Anderson Industries

BULLETIN NO: TBSA (0504)
DATE 25.06.07

Technical Bulletin

913-6. DES 16012 –AIQDWG 244 Rev 2 or AIQDWG 245 Rev 2

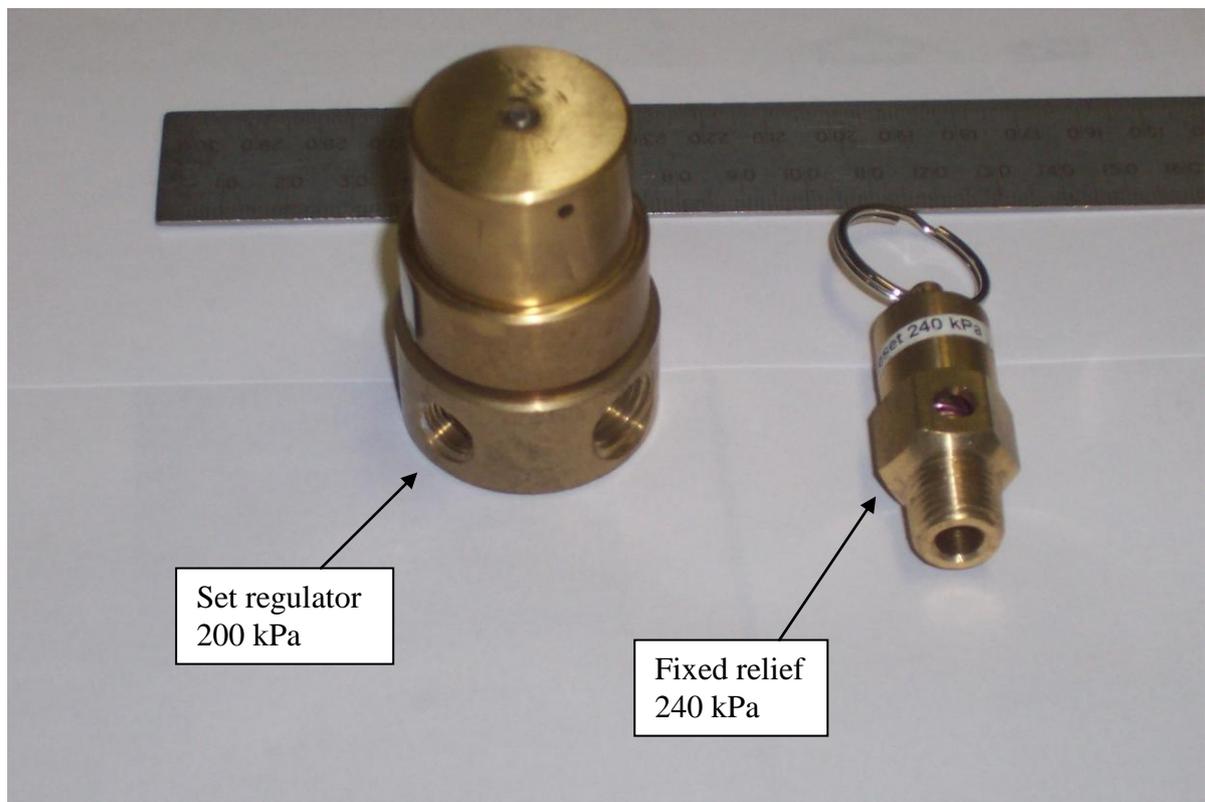
1. All 913-6 machines are to have socket headed cap screws replace the hexagon headed bolts on the cover over the top of the compartment containing the regulator
2. Install welded rings around the cap screws on the 913-6 machine.
3. Replace the existing adjustable regulator with a tamper proof low pressure pre-set regulator (29 psi, 200 kPa) Part number – AIQ 00741.
4. Install a fixed relief valve (35 psi, 240 kPa) Part number – AIQ 00742 to the safety circuit as per relevant schematic for each machine
5. Relocate the fixed restrictor Part No.AIQ00253 to a position prior to the low water shut down valve as per the relevant schematic. For the 913-6 LHD it is Item 14 and the Wright HD 356 LHD it is Item 9.
6. All end users to introduce and train their personnel on the Workplace instruction “WI-WSHOP 19 A1”.
